BALTIMORE COUNTY PUBLIC SCHOOLS

ADDENDUM NUMBER 2

BID NAME: NEW SCHOOL CONSTRUCTION LANSDOWNE ELEMENTARY SCHOOL
DEMOLITION OF LANSDOWNE ELEMENTARY SCHOOL

BID NUMBER: **MBU-516-17**

SK-S-10

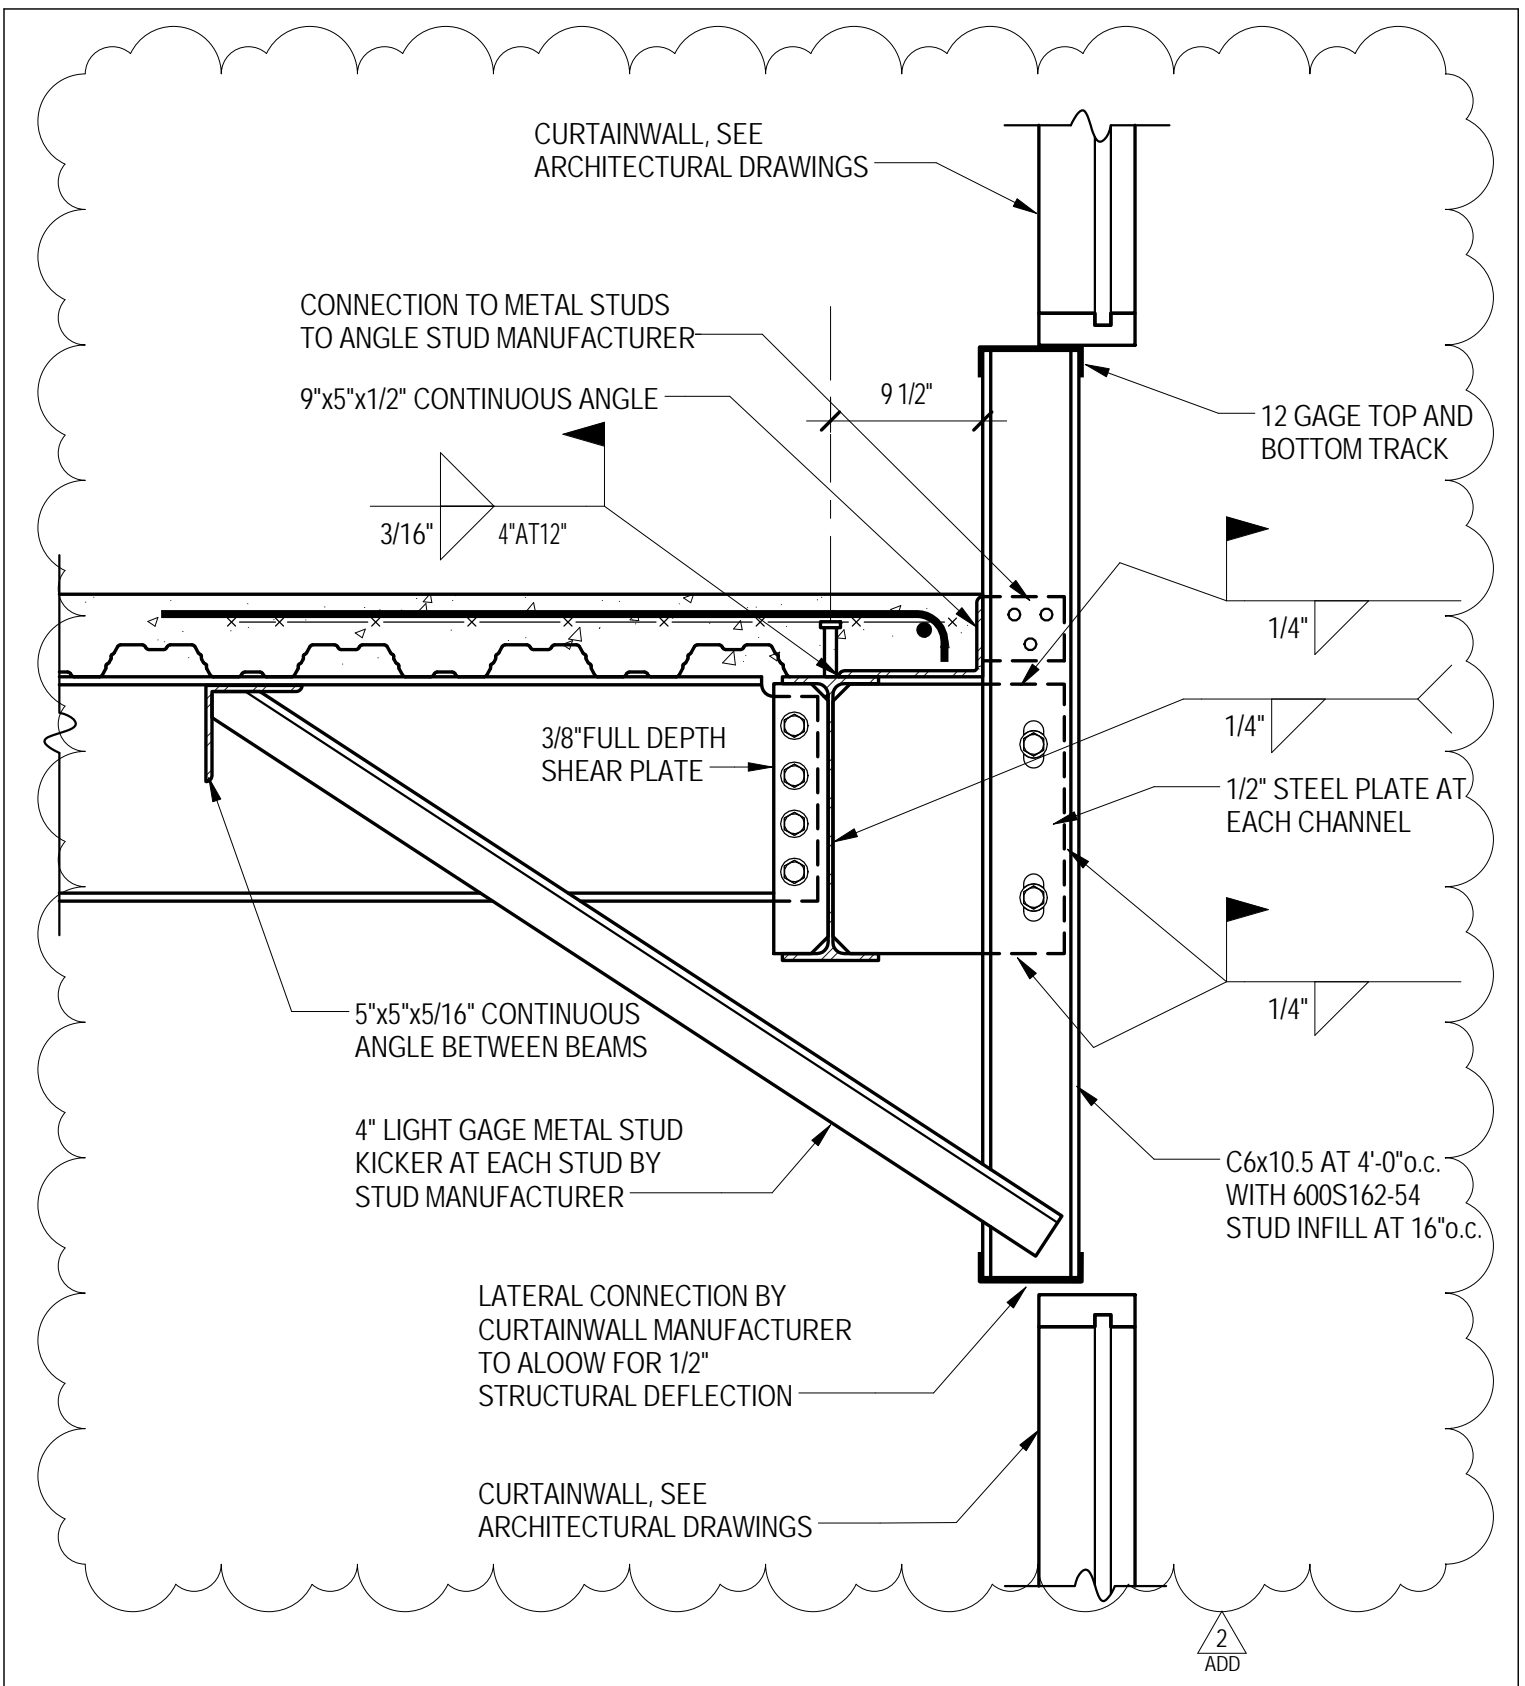
REVISE Section G/S5.6 per attached sketch SK-S-9.
REVISE Section H/S5.6 per attached sketch SK-S-10.
ADD Section J/S5.6 per attached sketch SK-S-11.
ADD Section K/S5.6 per attached sketch SK-S-12.

SK-M-1

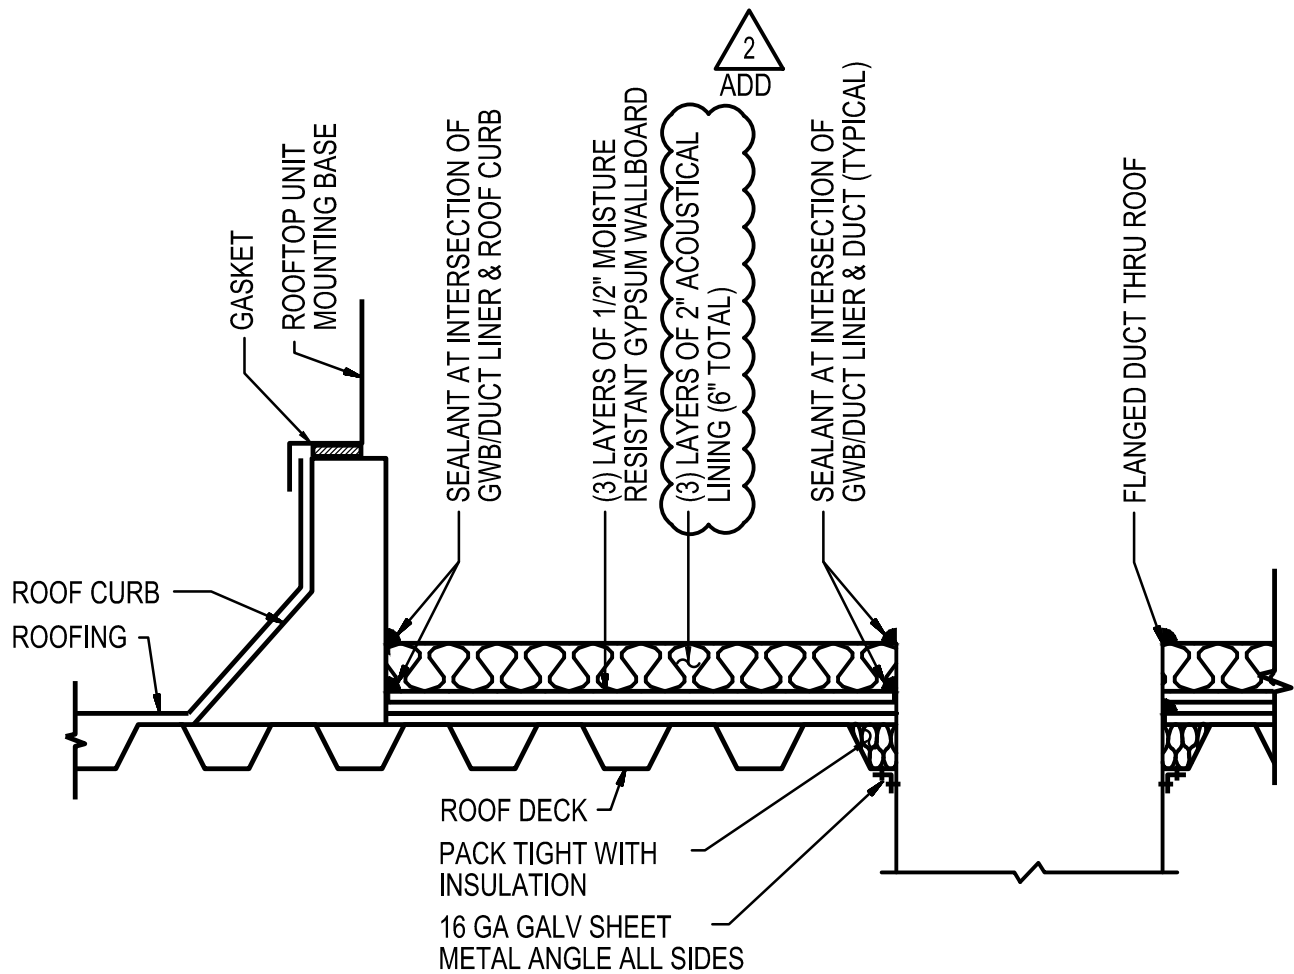
REVISE: Note as indicated on sketches SK-M-1 and SK-M-2.
